City of Biddeford Planning Board

May 21, 2025 at 6:00 PM
City Hall Council Chambers & Zoom

PLANNING BOARD STAFF REPORT

SITE PLAN.

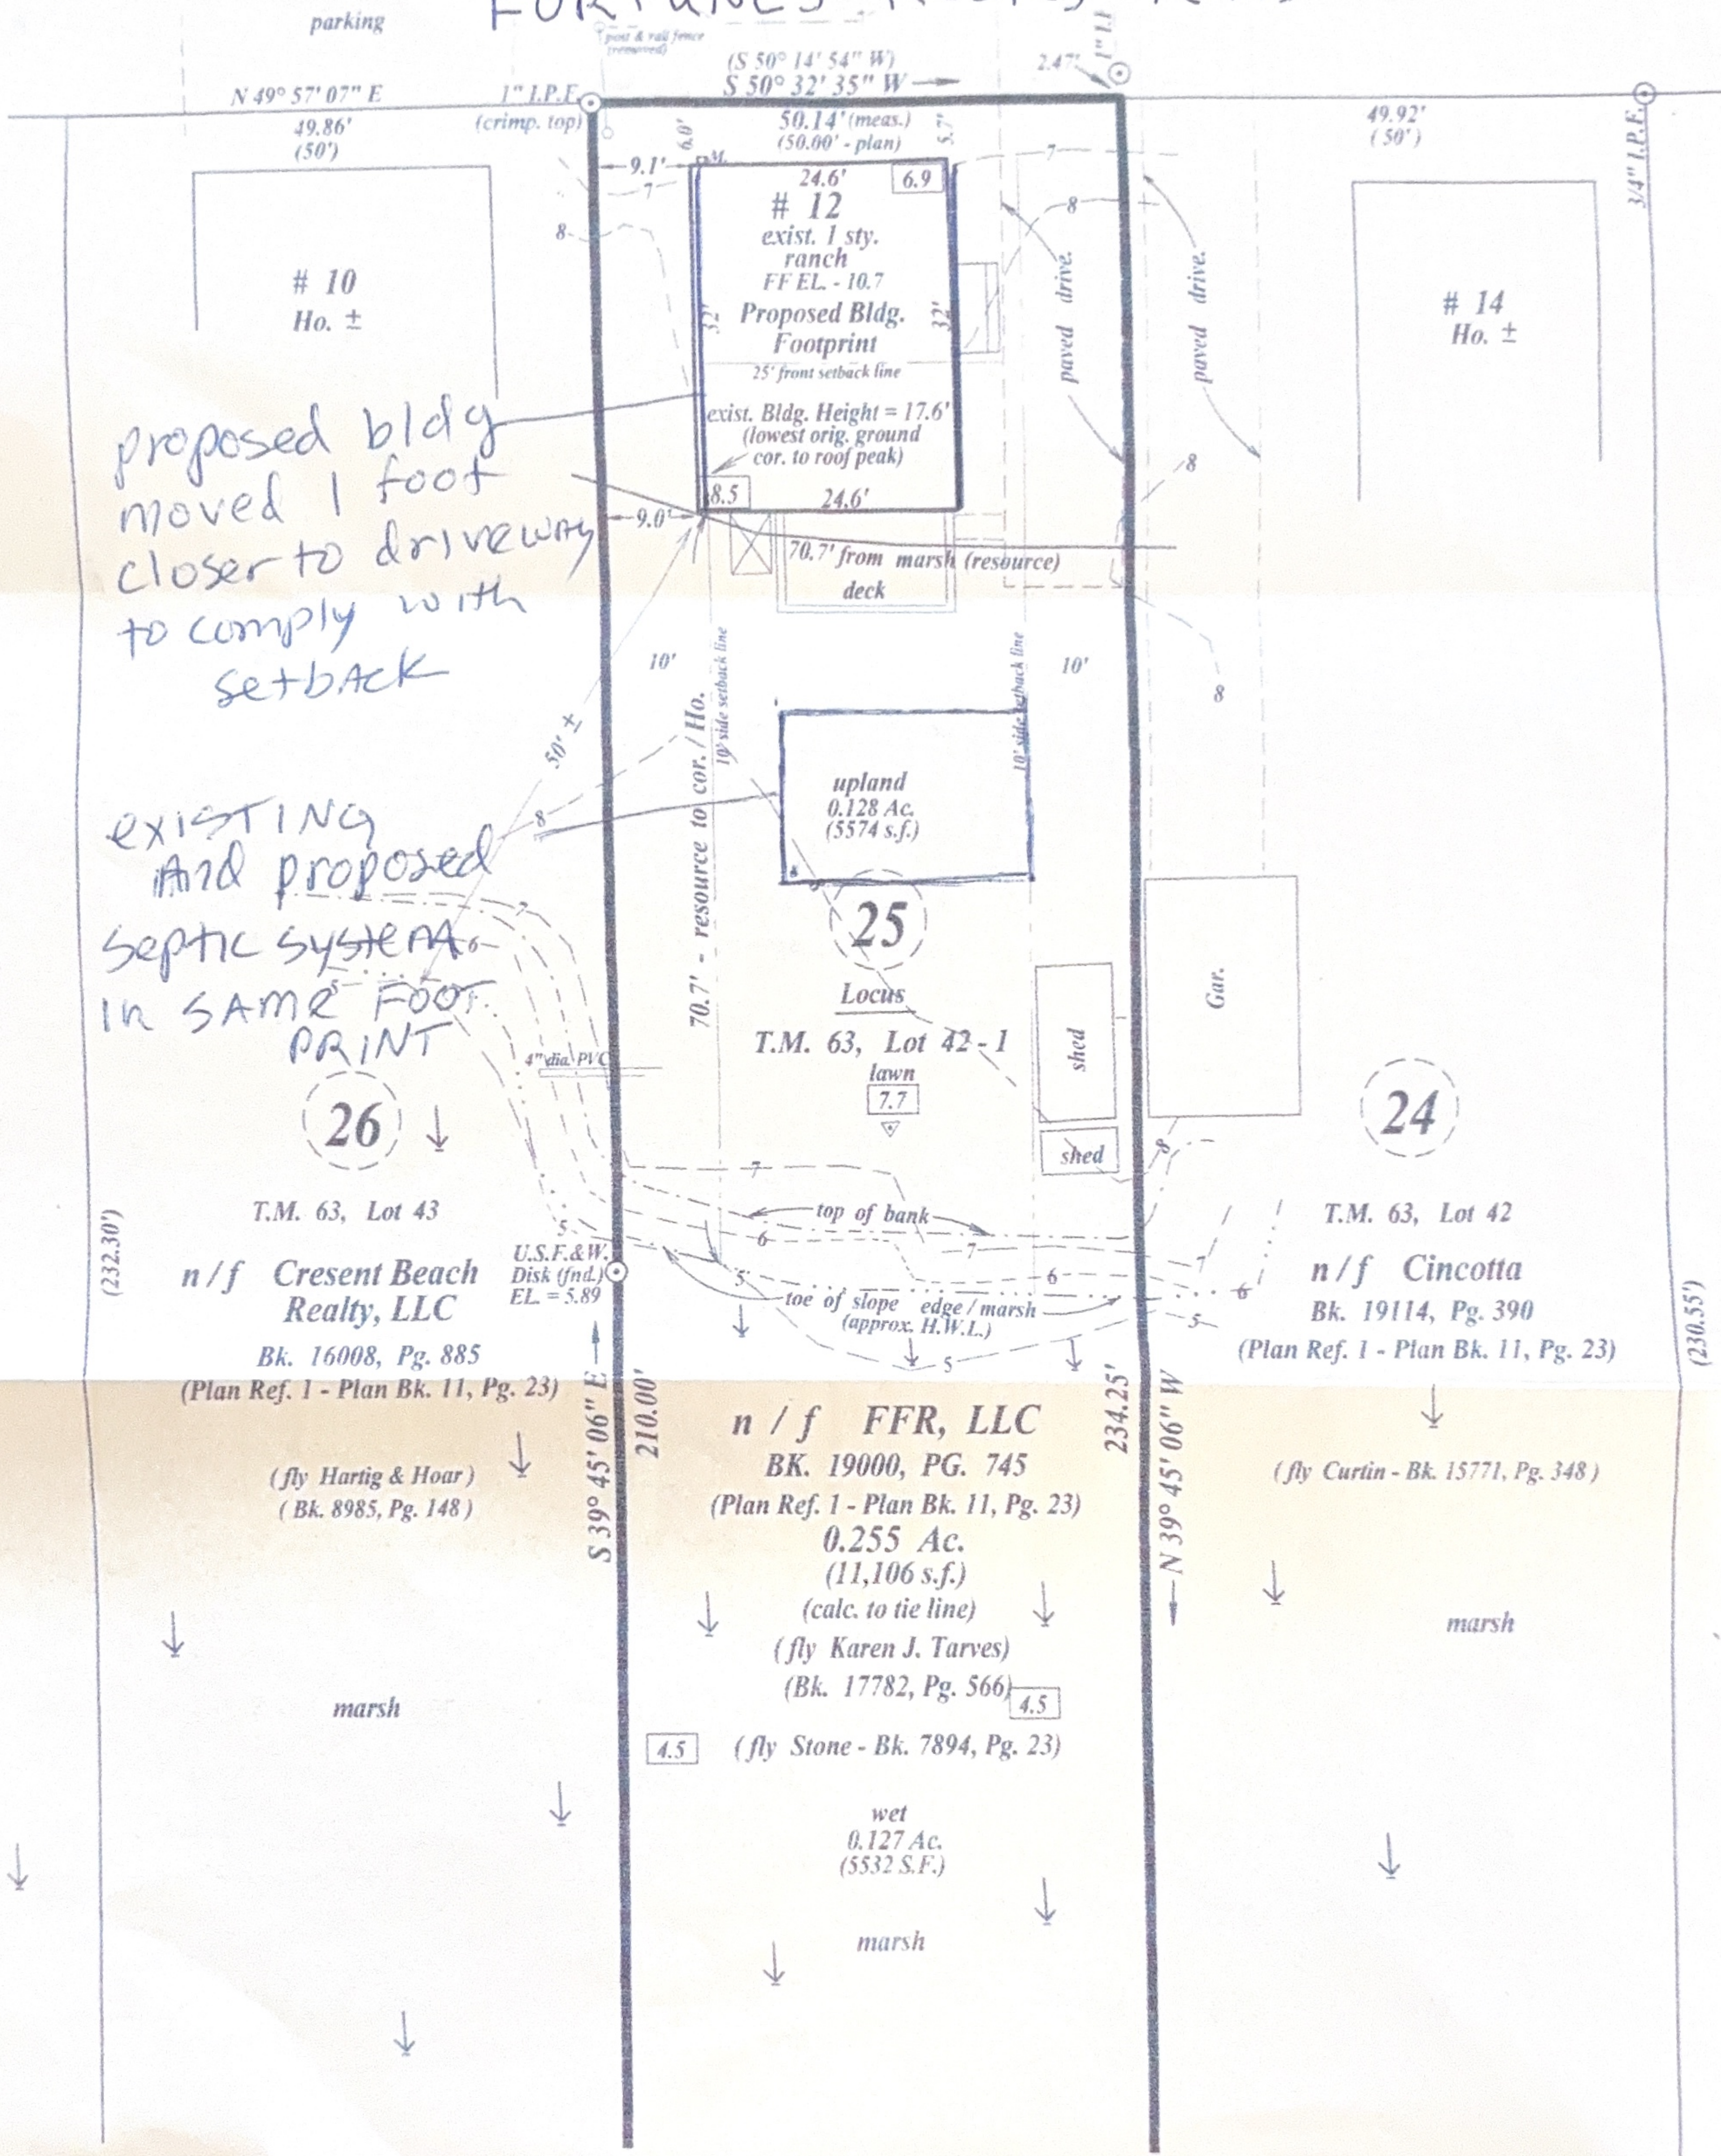
proposed bldg moved 1 foot closer to driveway to comply with setback

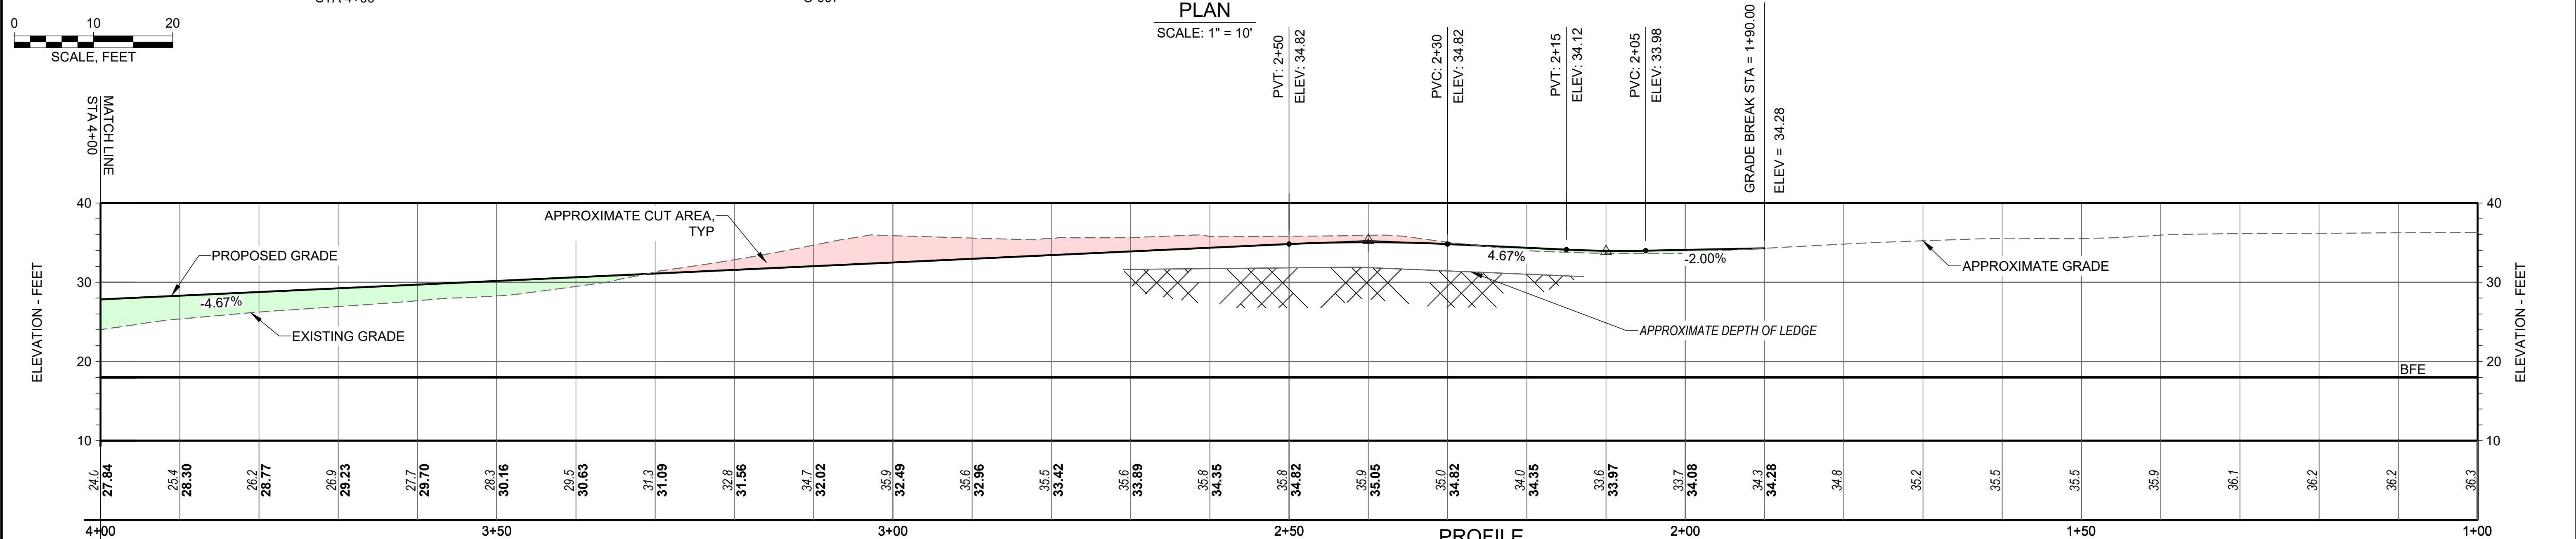
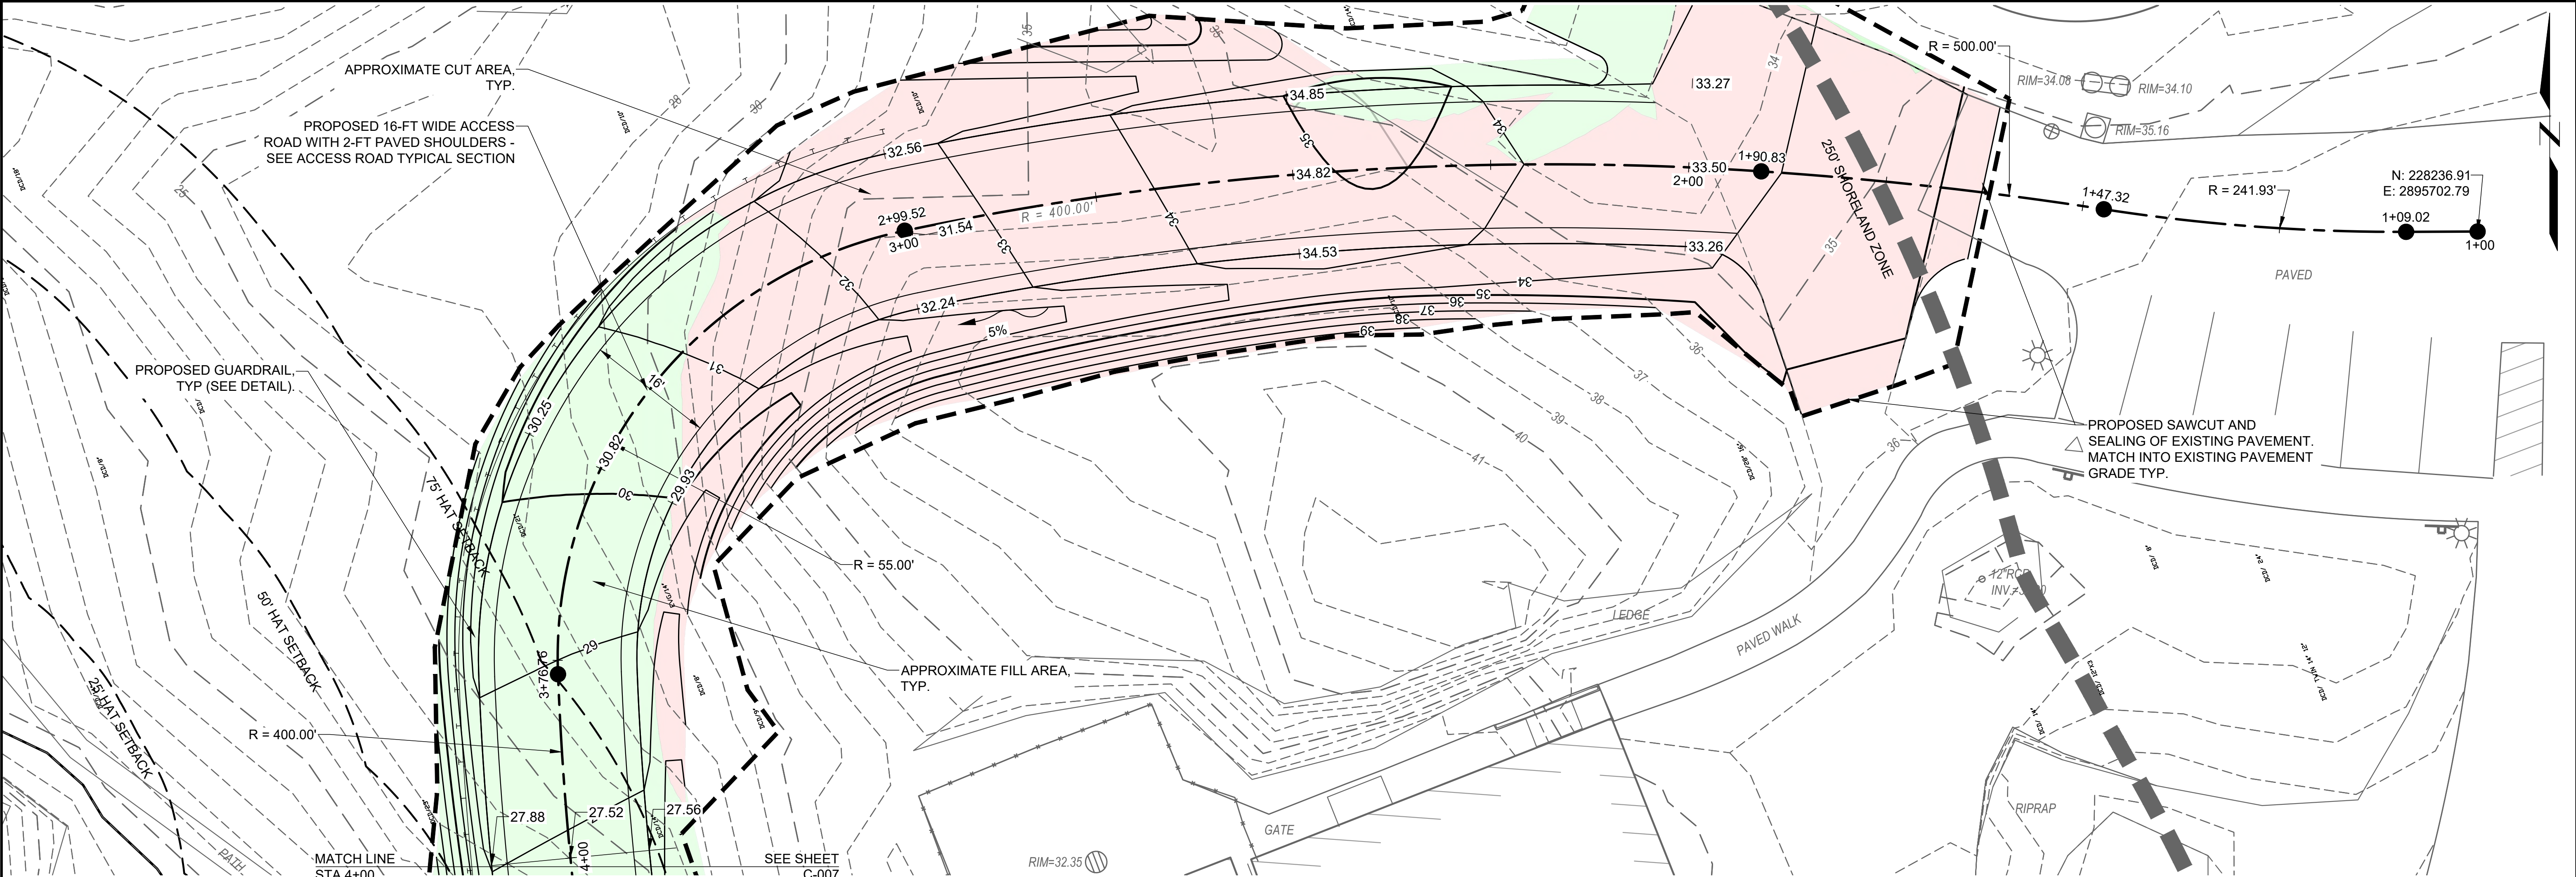
9. The Typical Section provided on sheet C-008 shows the 1:1 embankment starting behind the proposed guardrail. However, Plan View (C-006/007) shows the 1:1 embankment starting in front of the guardrail. The typical section and plan view should correlate. Additionally, an adequate guardrail "shelf" should be provided behind the guardrail posts for support.
